Project	IEEE 802.16 Broadband Wireless Access Working Group < http://ieee802.org/16 >	
Title	Framework for Enabling Closed-loop MIMO for OFDMA	
Date Submitted	2005-01-26	
Source(s)	<p>Wonil Roh, JeongTae Oh, Chan-Byoung Chae, Kyunbyoung Ko, Hongsil Jeong, Sung-Ryul Yun, Seungjoo Maeng, Jaeho Jeon, Jaeyeol Kim, Soonyoung Yoon</p> <p>Samsung Electronics Co., Ltd.</p> <p>Erik Lindskog, Harold Artes, Djordje Tujkovic, Kamlesh Rath, Andreas Bergkvist, V. Shashidhar, B. Sundar Rajan, Rahul Vaze, Bob Lorenz, Babu Mandava, A. Paulraj, Aditya Agrawal</p> <p>Beceem Communications, Inc.</p> <p>Young-Ho Jung, Seung Hoon Nam , Jaehak Chung, Yungsoo Kim, Sung-Jin Kim, Hojin Kim</p> <p>Samsung Advanced Institute of Technology</p> <p>Wen Tong, Peiyong Zhu, Ming Jia, Dongsheng Yu, Hua Xu, Jianglei Ma ,Mo-Han Fong, Hang Zhang, Brian Johnson</p> <p>Nortel Networks</p> <p>Qinghua Li, Xintian Eddie Lin, Sumeet Sandhu, Shilpa Talwar, Randall Schwartz, Alexey Davydov, Uri Perlmutter, Nageen Himayat, Minnie Ho</p> <p>Intel Corporation</p> <p>Bin-Chul Ihm, Yongseok Jin, Jinyoung Chun, Kyuhyuk Chung</p> <p>LG Electronics</p> <p>Kevin Baum, Mark Cudak, Tim Thomas, Fred Vook Xiangyang (Jeff) Zhuang</p> <p>Mot

Figure 231c - Mapping of MIMO coefficients [for quantized precoding weight](#) for enhanced fast MIMO feedback payload bits

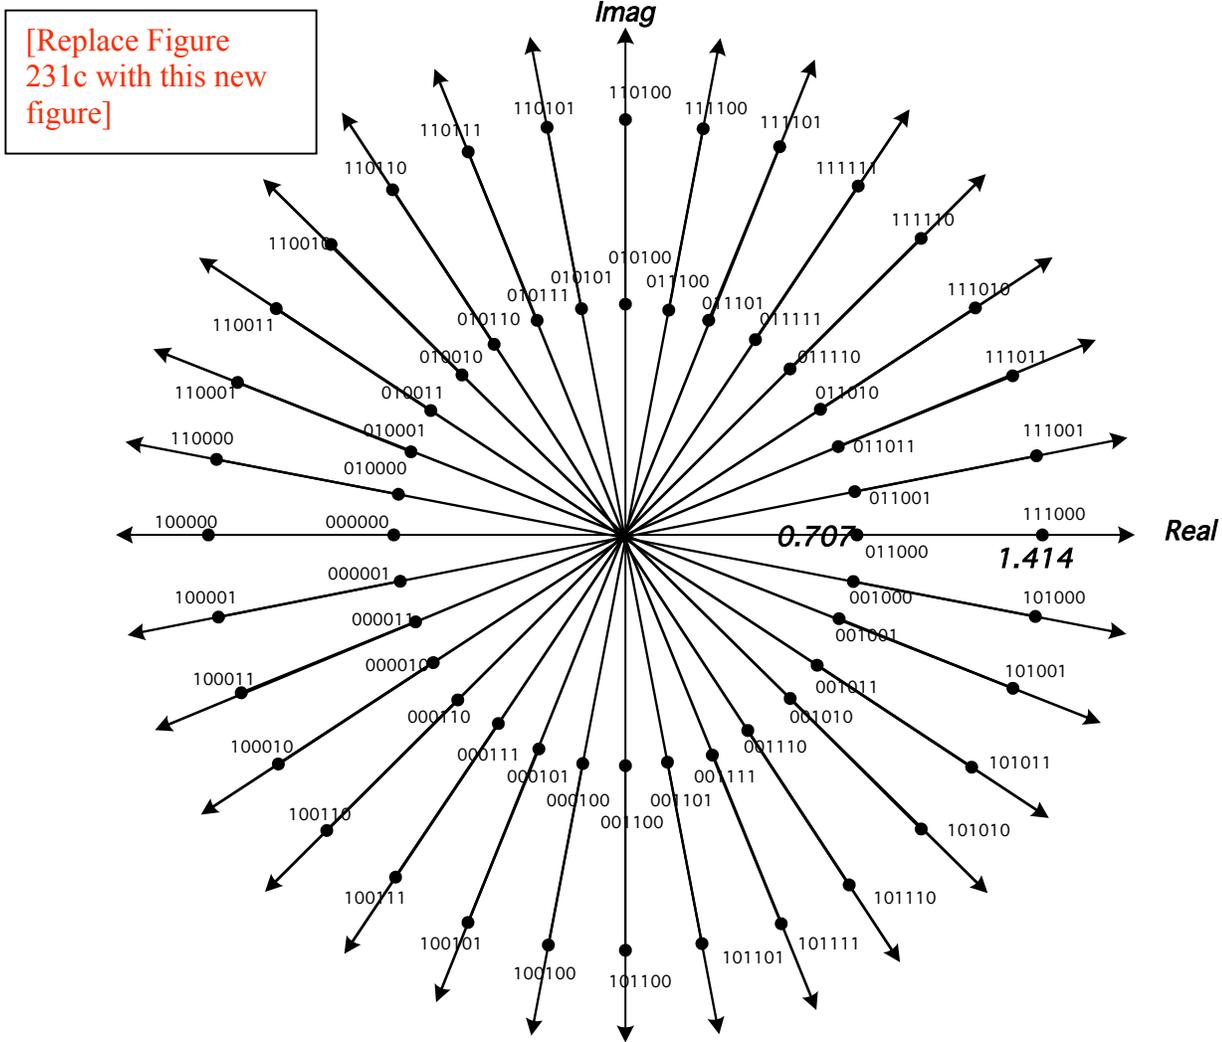
When the FAST_FEEDBACK subheader Feedback Type field is '01' or '10', or the CQI Feedback Type field in the MIMO Compact DL-MAP IE() (see 6.3.2.3.43.6.7) is 011, or the CQI Feedback Type field in CQICH_Enhanced_Alloc_IE() (see 8.4.5.4.~~15~~~~12~~~~1~~) is 011, the MSS shall report the MIMO coefficient the BS should use for best DL reception (~~see 8.4.8.1.6~~). The mapping for the complex weights is shown in Figure 231c, and the SS shall construct the 6 CQI bits with 0 as the MSB and the mapped code as the remaining LSBs. For this type of feedback, if N is

[the number of BS transmit antennas, then \(N-1\) CQICH shall be allocated to the SS and SS shall report the desired antenna weights of antenna 1 through N-1 based on antenna 0.](#)

Figure 1 H-ARQ Enabled Vertically Encoded 2x2 MIMO System

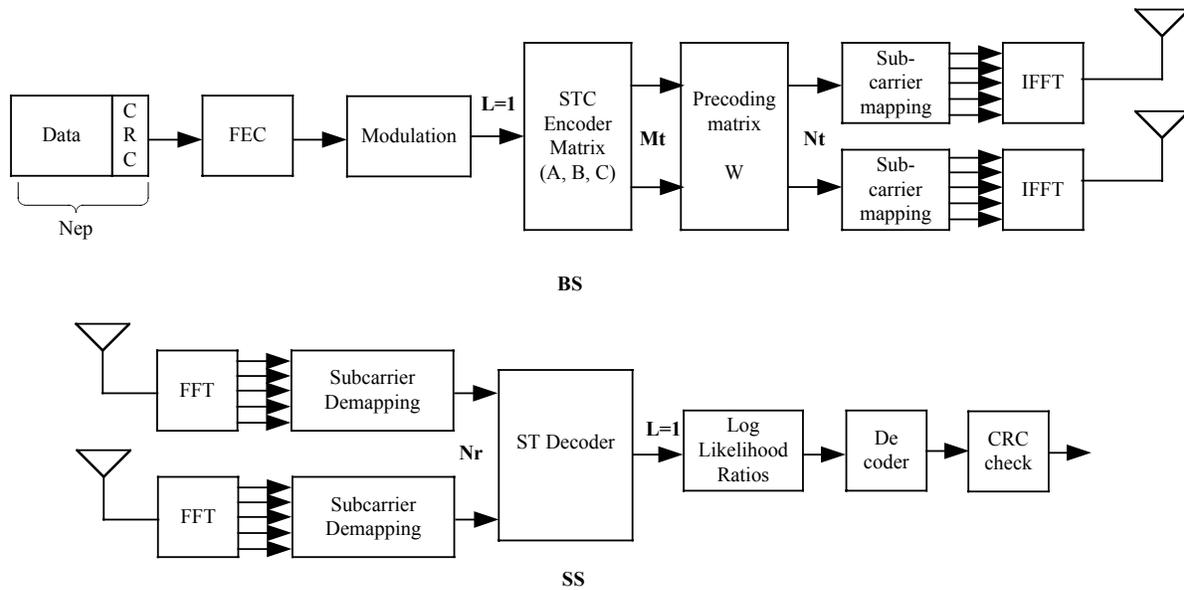
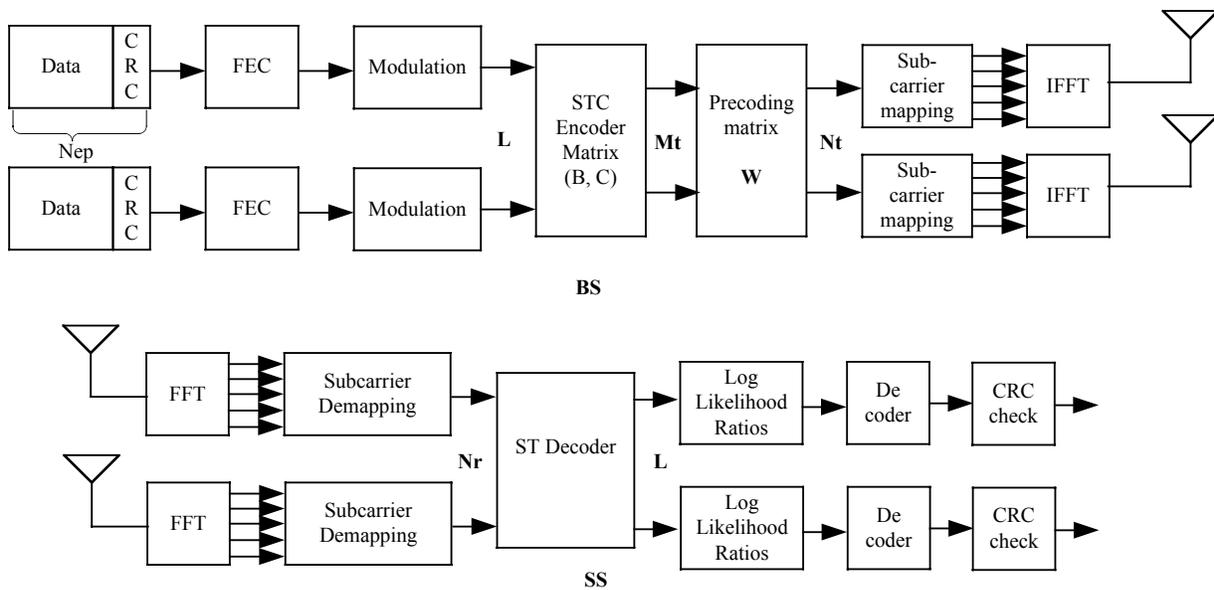
Some clarification is made on burst mapping for H-ARQ when multiple MIMO layers are transmitted on the same physical resource. The multiple layer transmission is enabled when spatial multiplexing (SM) schemes are employed with multiple modulation and coding blocks implemented for each spatial layer. We call it horizontal encoding (HE) and this mode enables adaptive rate control for each spatial layer. The other class of spatial multiplexing schemes is called vertical encoding (VE) and it features a common modulation and coding block. Transmit diversity (TD) can be also regarded as single layer technique. Figure 1 shows an example of 2x2 VE MIMO system, whereas Figure 2 illustrates that of 2x2 HE MIMO system. In both figures, L equals the number of layers, M_t the number of STC output streams, N_t the number of BS transmit antennas, and W denotes the precoding matrix. Their relations according to the current standard are tabularized in Table 5.

In both Figure 1 and Figure 2, when there is no precoding matrix at Tx, Mt becomes the number of transmit antennas. In Table 1, the existing open-loop matrices (A, B, or C) are noted and the superscript ¹ indicates the applicability of the antenna grouping technique.
